LAND USE CONSIDERATIONS

PLANNED UNIT DEVELOPMENT (PUD) ZONING

RESPONSE TO PRIMARY CONCERNS/COMMENTS

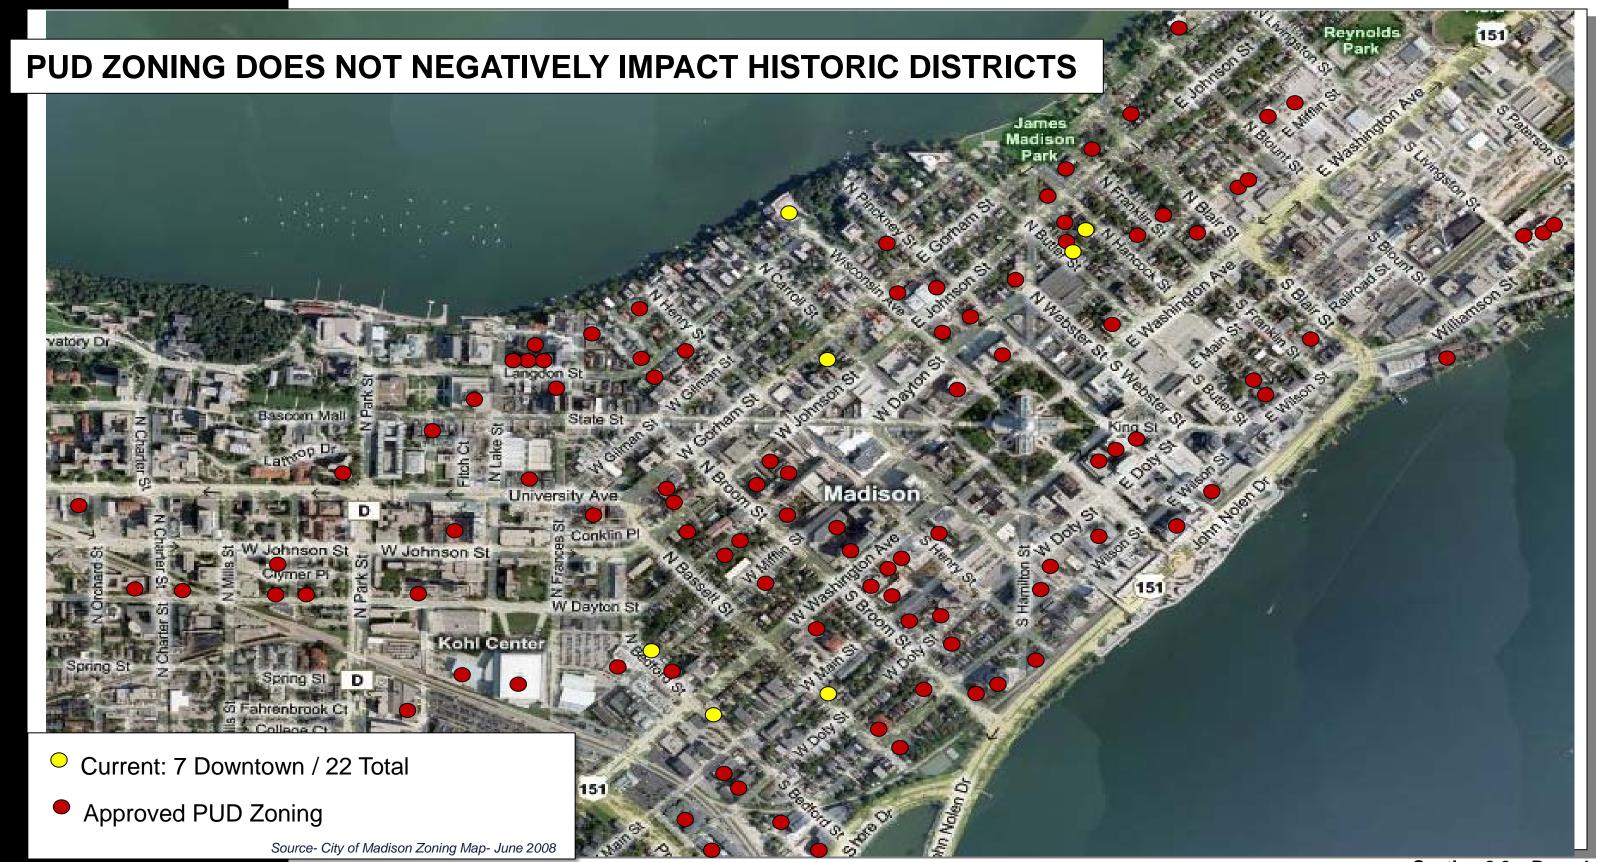
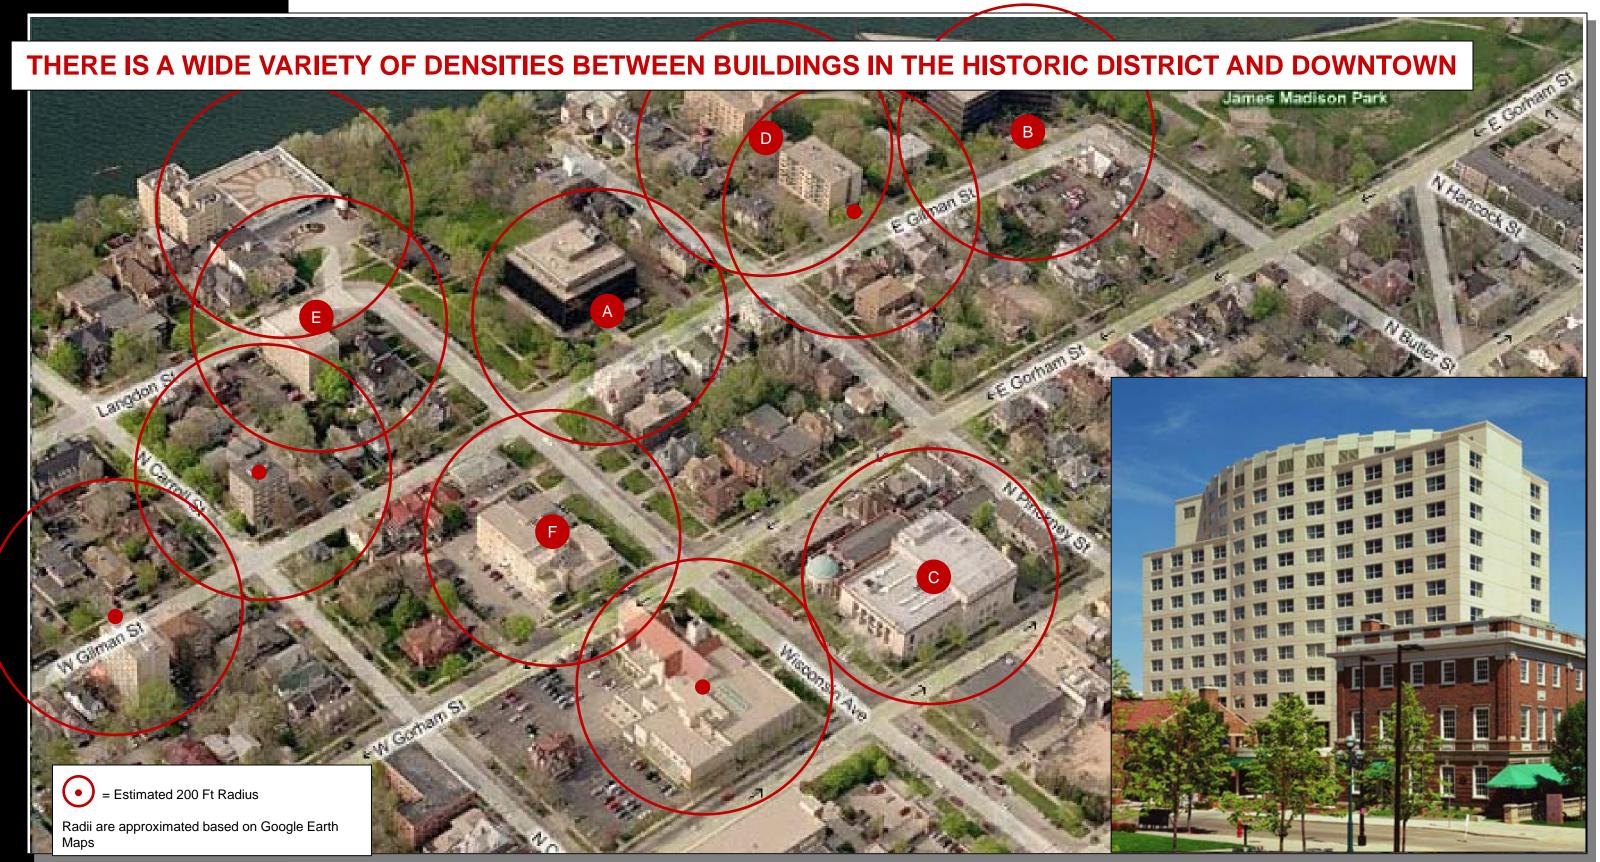
QUESTION:

It has been stated that the proposed planned unit development (PUD) is a violation of existing zoning code. Is the PUD zoning classification unusual by City of Madison standards?

ANSWER:

There is absolutely no basis for the claim that this PUD is somehow out of the norm by City of Madison zoning standards.

- PUD has been the dominant zoning classification for downtown development over the past decade;
- The Edgewater PUD zoning text is among the most restrictive of all PUD's approved by the City of Madison;
- This PUD zoning text only allows the proposed height on this site if the following conditions are satisfied:
 - Requires a site area of more than 1 acre
 - Requires access to a major civic roadway
 - Requires a minimum of 15,000 square feet of open space
 - Requires public access to the waterfront
- The PUD zoning criteria above mitigate zoning precedent concerns because it would be extraordinarily difficult for any other site downtown to meet these requirements that allow for the proposed height of the Edgewater.

LANDMARK ORDINANCE

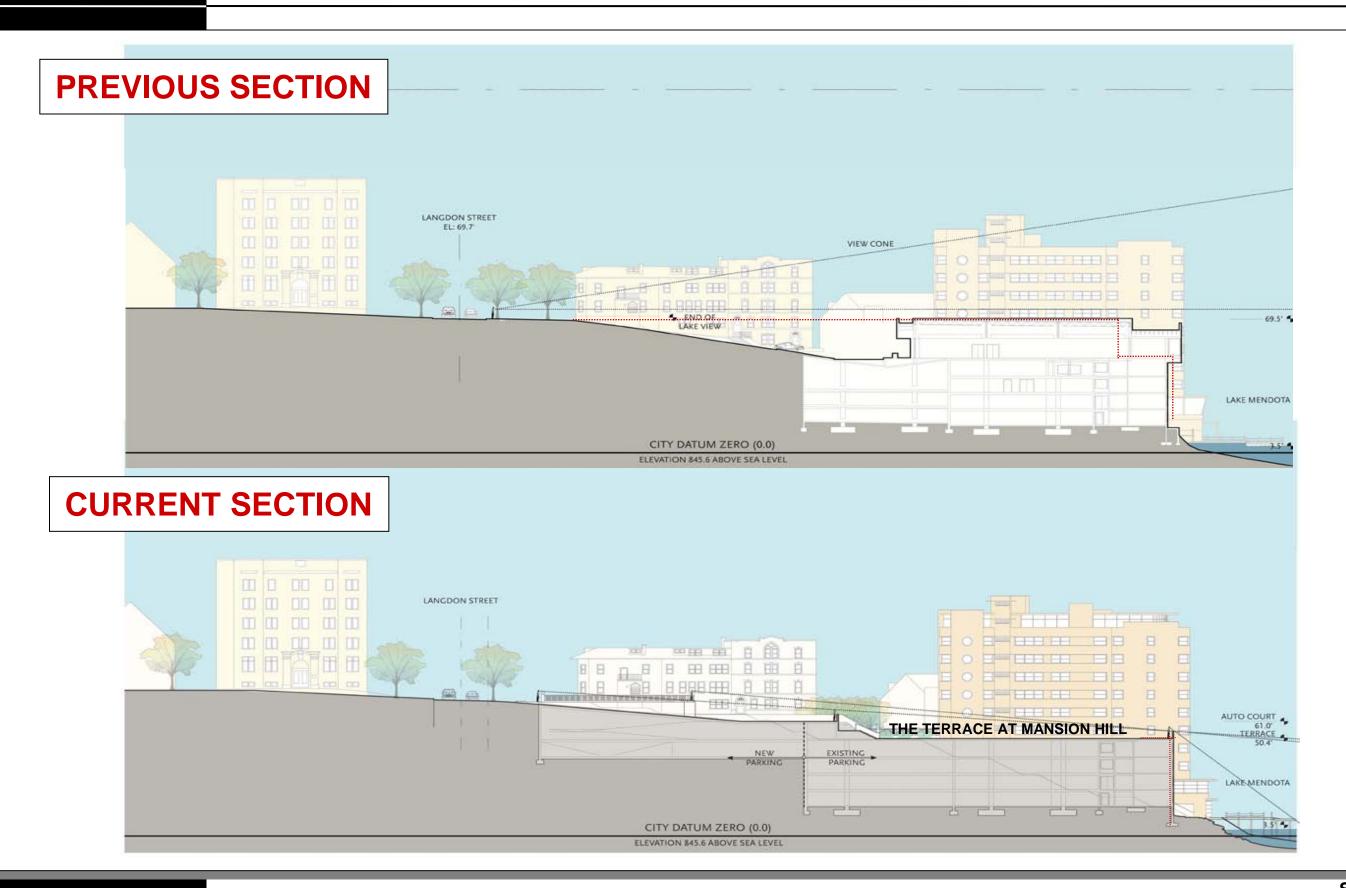
QUESTION:

What is the impact of the Project to the Historic District?

ANSWER:

- The Mansion Hill Historic District was established to protect the 1800 and early 1900 era Mansions which are a part of this neighborhood. The Project is not located near any of these mansions and will not adversely effect the character of the mansions or the district;

- The Project is located at the end of one of the most prominent civic streets in Madison. It is the anchor to Wisconsin Avenue and to the primary civic and commercial boulevard that services the Historic District;

- The Mansion Hill historic district ordinance requires buildings to be compatible with the other buildings that are within a defined radii of the site. The use and character of the buildings surrounding the Edgewater, include:

- Buildings immediately adjacent to the site include a fraternity, 3 multi-story residential buildings and a commercial office building. There are no single family or small-size dwelling units adjacent to the Property;

- The Project is compatible with the height of Kennedy Manor and the National Guardian Life building which sit adjacent to the Project;
 - The Project has been designed to compliment the historic and classical architecture of buildings in the neighborhoods, especially Kennedy Manor which sits across the street from the site;

- The Project will have a positive impact in the district as it will add amenities (e.g. restaurants, café, spa, etc.) and become a catalyst to the TIF district which will enhance the urban, residential character of the neighborhood.

THE HISTORIC "HILL" ON WISCONSIN AVENUE

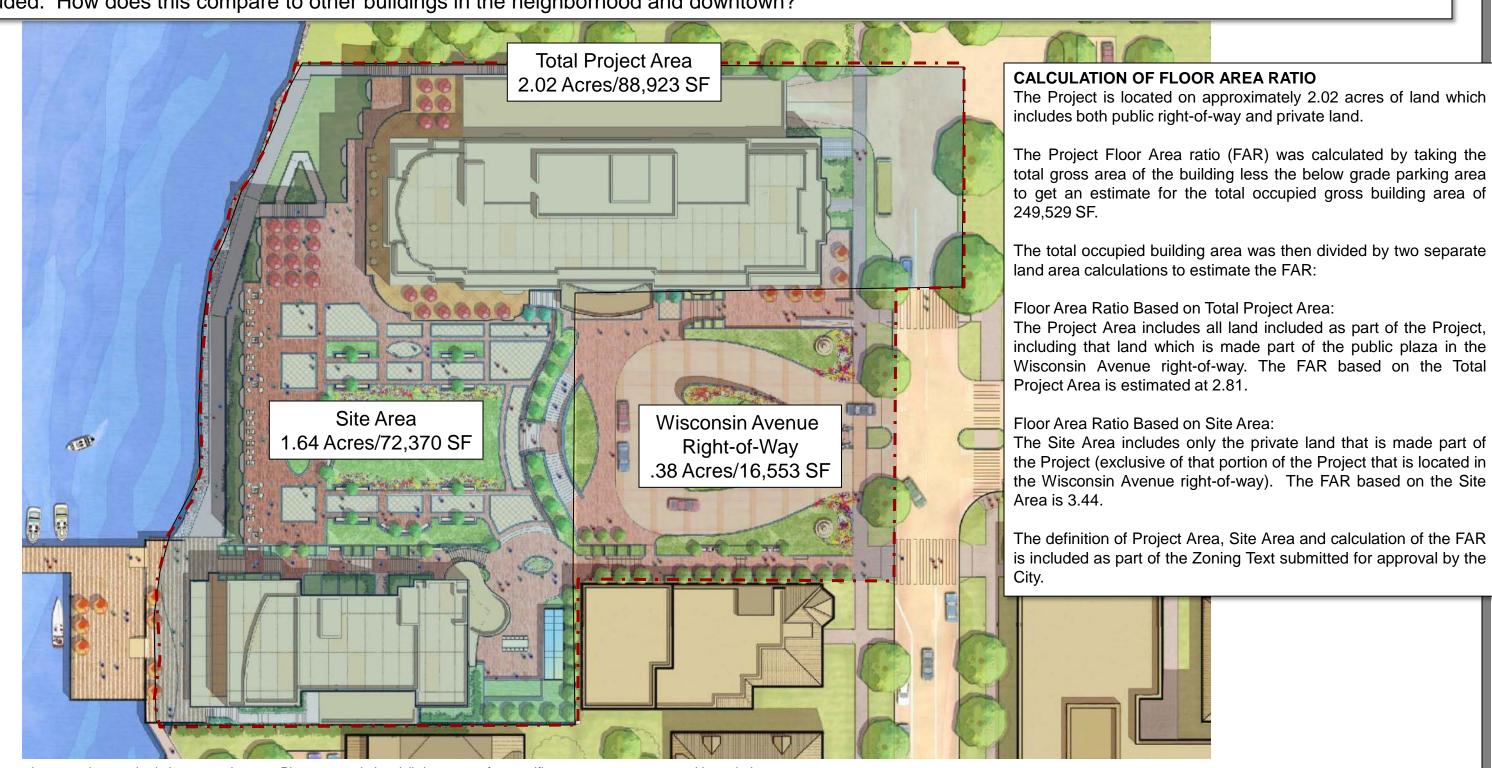
QUESTION:

One of the concerns expressed among certain neighborhood interests has been the historic significance of the "hill" on Wisconsin Avenue. How has this been considered in the plan for the Edgewater?

ANSWER:

The historic "hill" has become the driving force behind the redesign of the Project.

- Our vision in the redesign is to develop The Terrace at Mansion Hill by recreating the "hill" that was lost when the 1970's addition was constructed;
- A central theme of the project is to rebrand the property as "The Edgewater at Mansion Hill" to play on the importance
 of the hill as a focal point of the historic district;
- By creating a tiered terrace vs. a level terrace at street elevation we can capture the historic importance of the "hill";
- This concept greatly enhances the view corridor from Wisconsin Avenue to Lake Mendota.

VIEW TO AND FROM LAKE MENDOTA

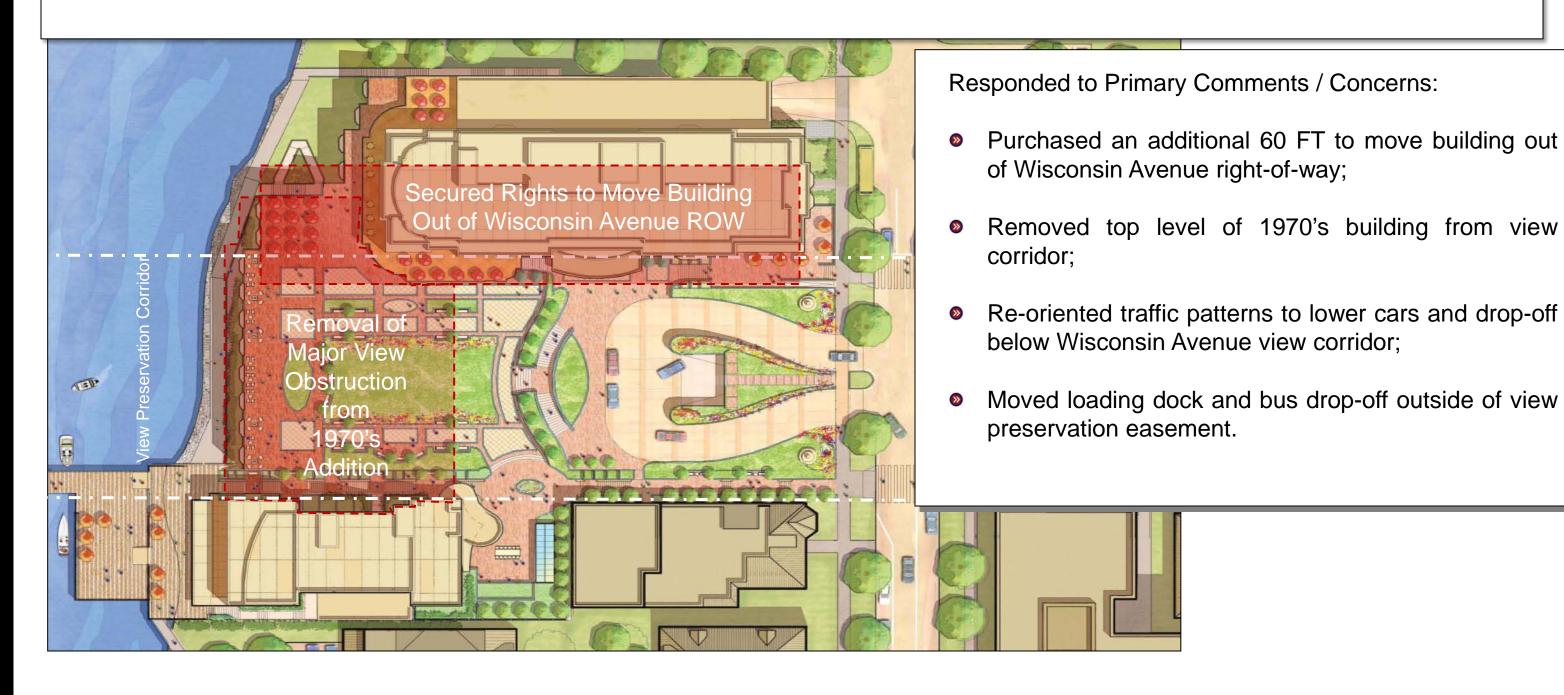
INFORMATION REQUEST: EXPLAIN PRIMARY CHANGES IN DESIGN THAT HAVE ALLOWED FOR OPENING OF VIEW CORRIDOR

THE PROPOSED REDEVELOPMENT WOULD REMOVE THE 1970'S STRUCTURE OPENING THE VISTA TO THE WATER.

TRAFFIC AND CIRCULATION

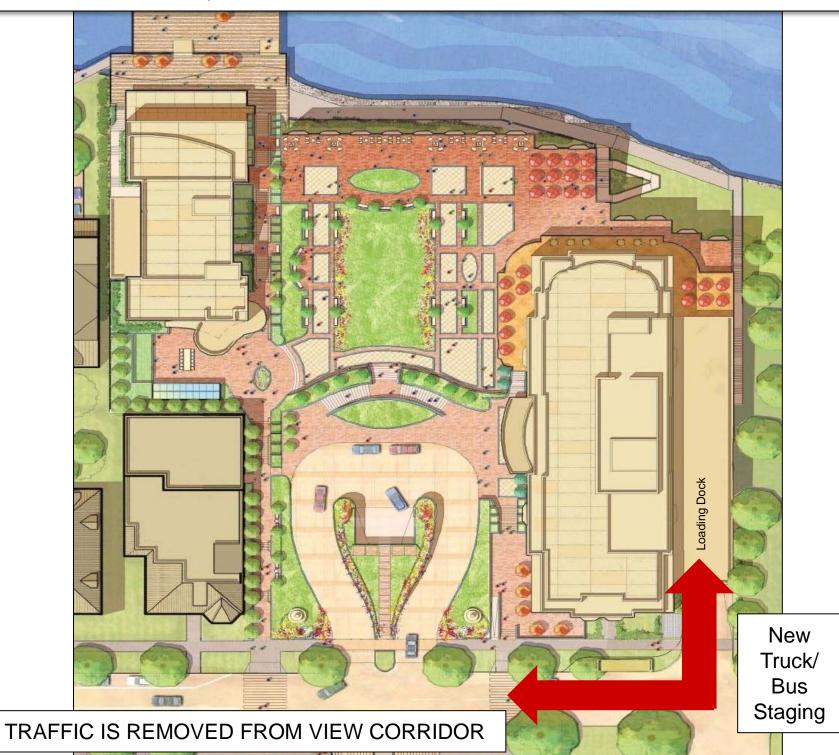
INFORMATION REQUEST: ESTIMATE DEMAND AND INCREMENTAL IMPACTS OF TRAFFIC ON THE SITE.

Existing	Proposed
Trips / Room / Day	6.24	8.92
No. of Rooms	<u>107</u>	<u>185</u>
Total Daily Trips	668	1,650

Total Incremental Trips 983

Wisconsin	<u>Langdon</u>
Incremental Traffic	786	197
Current Traffic	<u>7,000</u>	<u>5,800</u>
Total Estimated Traffic	7,786	5,997

Percent of Capacity 55% - 65% 45% - 55%

TRAFFIC AND CIRCULATION

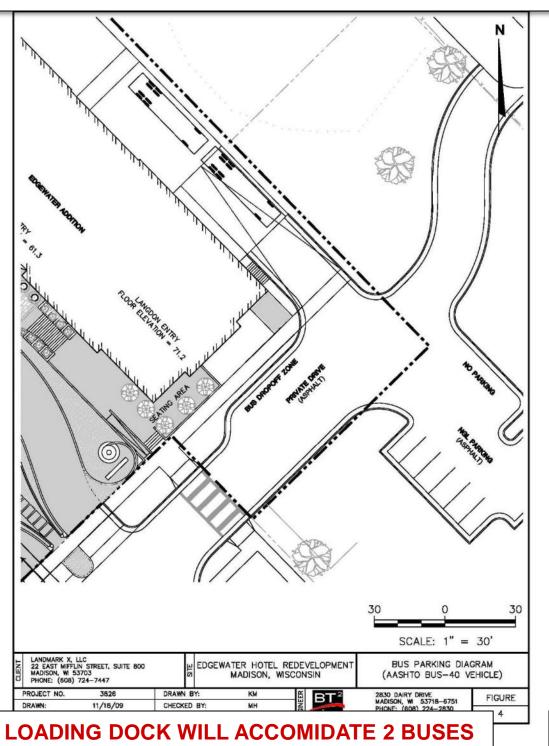
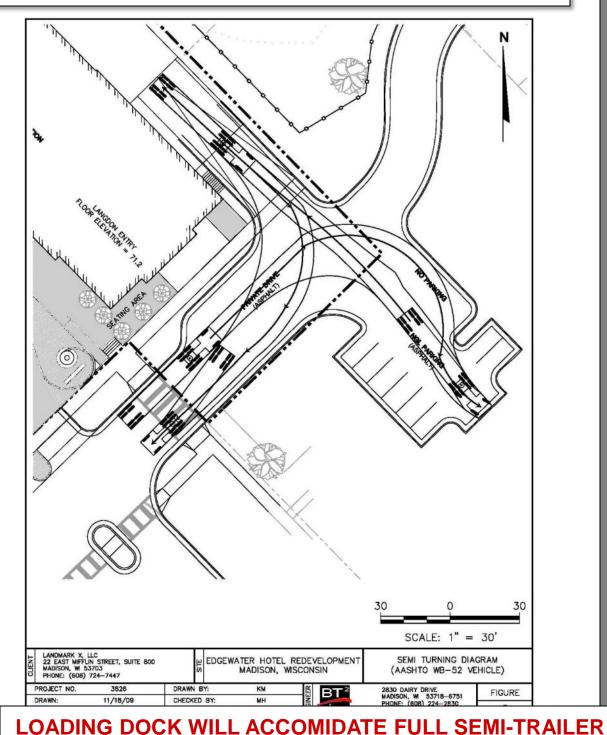
INFORMATION REQUEST - EXPLAIN BUS AND TRUCK LOADING ON THE SITE.

LOADING AND UNLOADING TODAY

SUSTAINABILITY STRATEGIES

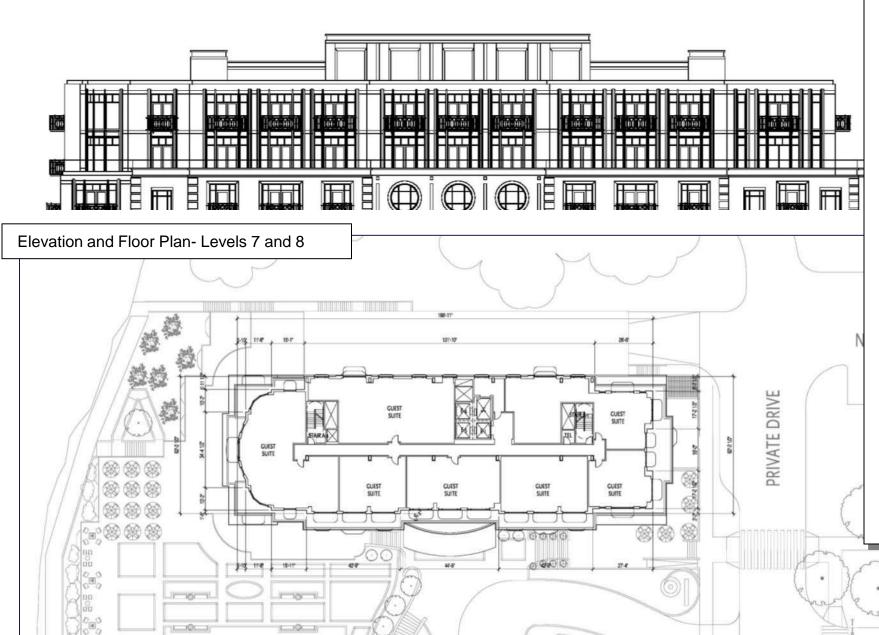
INFORMATION REQUEST - CONSIDER LEED CERTIFICATION.

One of our core objectives for the Edgewater redevelopment is to become a showcase for innovative green building design and technologies both locally and nationally. Our Green Building Program will focus on eight (8) core areas of concentration – renewable construction practices, sustainable site development, innovative design technologies and solutions, water savings, conventional / non-conventional energy efficiency, materials selection, the indoor environment and sustainable operations.

We have begun an analysis – including the evaluation and experiences of similar properties - to explore applications in the design and operation of the Edgewater that will be considered in the development of our Green Building Program and potential LEED or other sustainable strategies, including:

- Renewable Construction Practices Prioritize use of renewal resources in construction to minimize construction waste;
- Sustainable Site Development Landscape design for terrace that mitigates stormwater impacts using adaptable plant species, rebuilding shoreline banks, maintaining grade control, etc;

- Innovative Design Technologies and Solutions Building management systems that can optimize operations through use of variable speed equipment, new elevator technologies, etc;

- Water Savings Utilize high efficiency fixtures and equipment;
- Conventional / Non-Conventional Energy Efficiency Consider applications for innovative energy technologies such as solar and thermal;

- Materials Selection Research and apply material selections with the highest efficiency and optimal use of natural products;
- The Indoor Environment Design solutions to maximize natural resources (e.g. light, fresh air, etc.) and use of efficient materials;

- Sustainable Operations Maximize utilization of renewable resources with highest concentration of recycled content.

PROVIDE DETAIL ON RESIDENTIAL UNITS

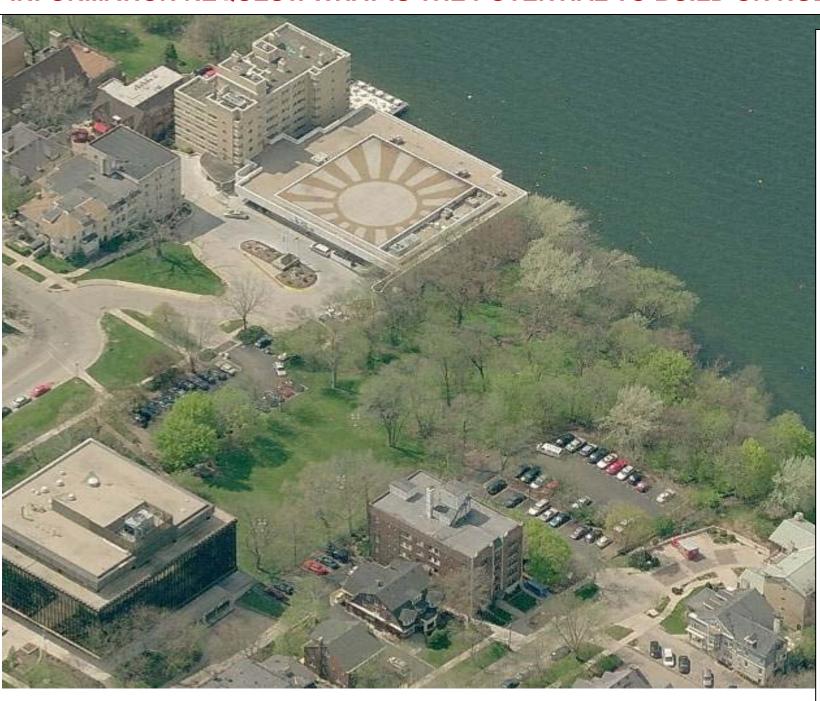
INFORMATION REQUEST - PROVIDE DETAIL ON PROPOSED RESIDENTIAL UNITS.

- A portion of the guest suite program may be converted to a limited number of condominium units on-site
- Condominiums have been contemplated in new tower or 1940's buildings. Currently, condominiums are contemplated in the top two floors of the new building;
- The total square footage of these floor plates 10,940 / floor.
- It is likely condominiums would be limited to 8-10 units;
- Additionally, addition of permanent residents to the building should aid in mitigating concerns about noise, operations, etc. with surrounding neighbors as there will be owner-residents on-site.

The Addition of Condominium Units to the Building Is Consistent with Neighborhood Objective to Increase Owner-Occupied Housing In the Area.
